Questions to Positron Group from CRWG (Central Region Working Group)

Shielding Wall between Service and Accelerator Tunnels

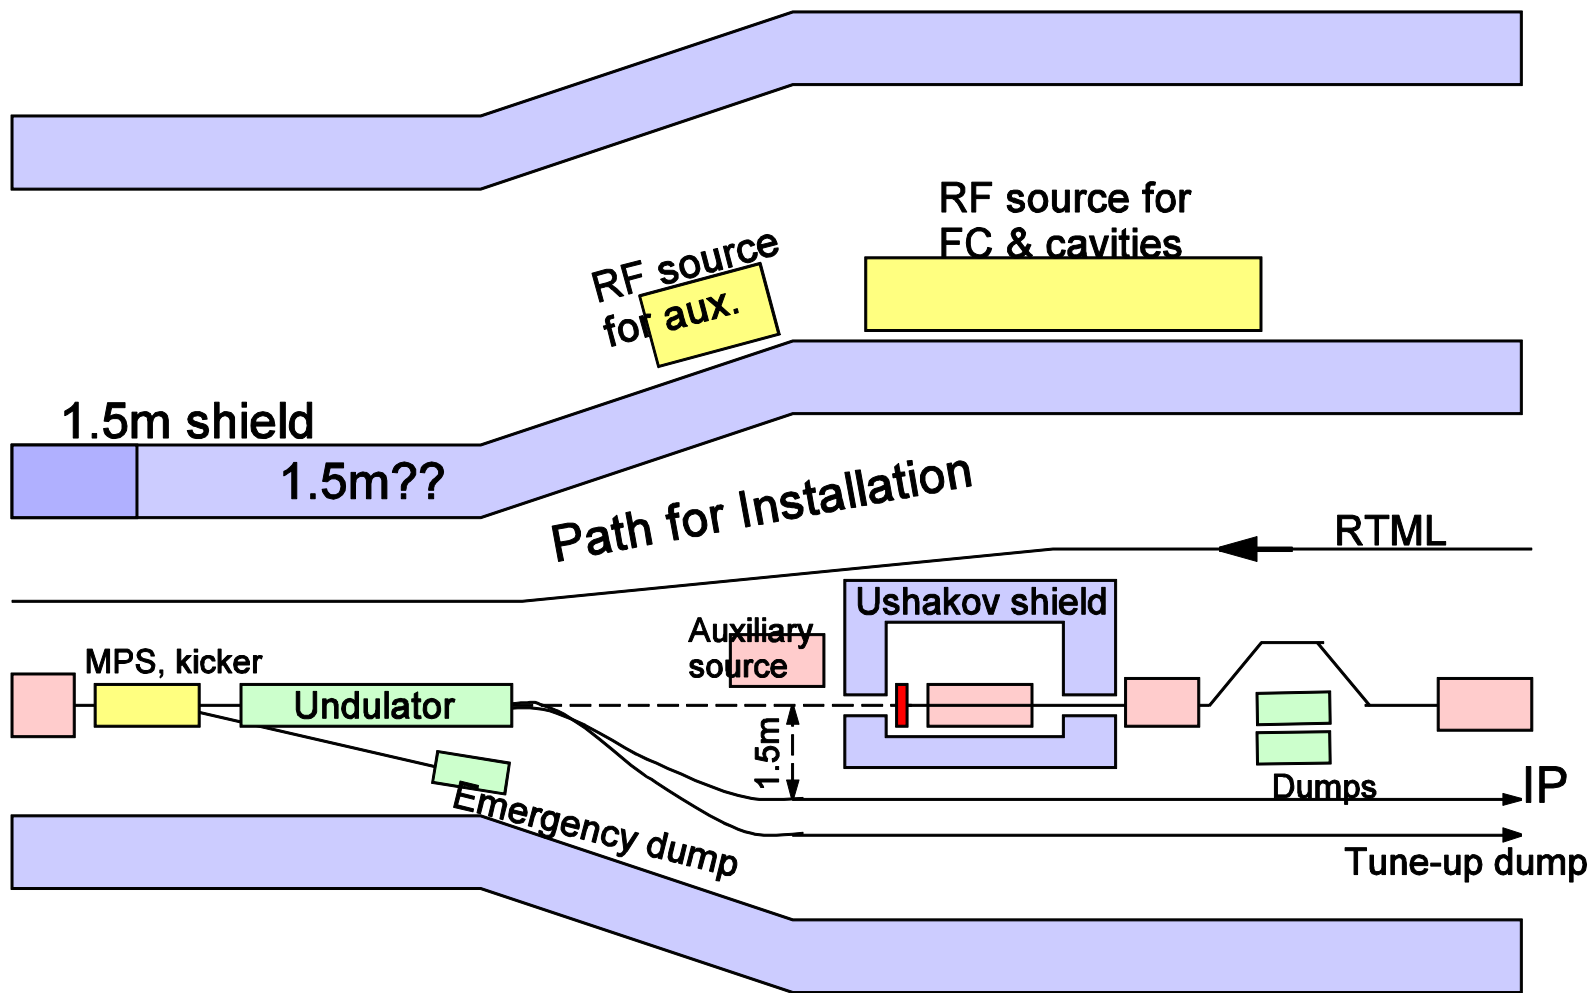
- The thickness of the shielding wall separating the service tunnel and the accelerator tunnel in the main linac region is being studied. Seems to converge to 1.5m (from 3.5m in TDR).
 - This is possible under the constraint of no human access to the service tunnel during the main beam on.
 - 1.5m is sufficient when RF is on but beam is off.
- The shielding wall in the BDS region is now a concern in the CRWG
 - TDR describes only twin tunnel as a solution for flat region. No design for mountain region is given.
 - Natural extension from Kamaboko tunnel in ML region to BDS region would also be Kamaboko (we assume this in the present questions)

Question A

- Is human access to the service tunnel in the positron source region necessary when the main beam (150GeV) is on?
- Answer:
 - The commissioning has to be made without necessity of any access during the operation.
 - Radiation level has to be controlled to avoid any damages on equipment in the service tunnel.
 - Radiation level has to be controlled to allow access to the service tunnel several hours later after the beam is turned off according to ALARA principle.
